Application No.: 10/662,356
Art Unit: 2836

IN THE DRAWINGS

REMARKS

Fig. 2B

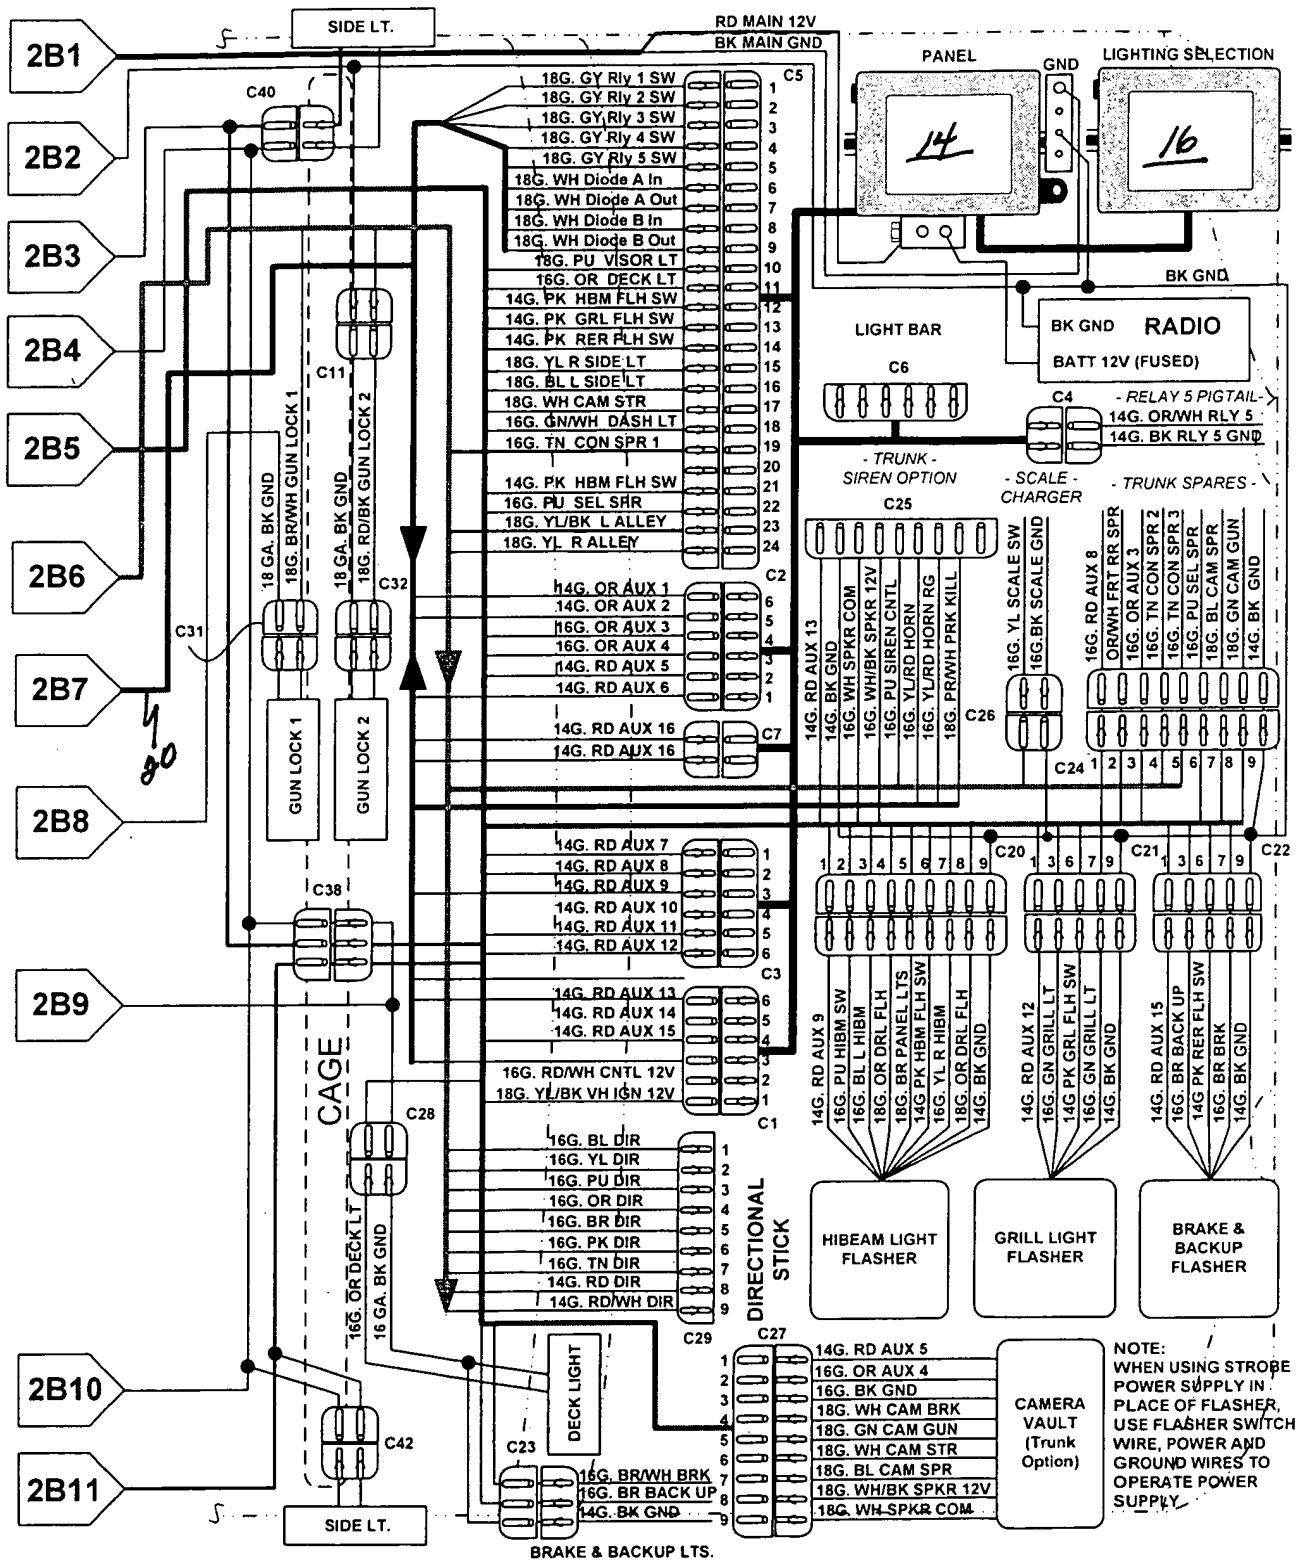
The attached sheets of drawings include changes to Figs. 2A, 2B and 4. These sheets, which includes Figs. 2A, 2B and 4, replaces the original sheets including Figs. 2A, 2B and 4. In Figure 2A, previously omitted reference characters --18-- and --20-- have been added. In Figure 2B, previously omitted reference characters --14--, --16-- and --20-- have been added. In Figure 4, previously omitted reference character --20-- have been added.
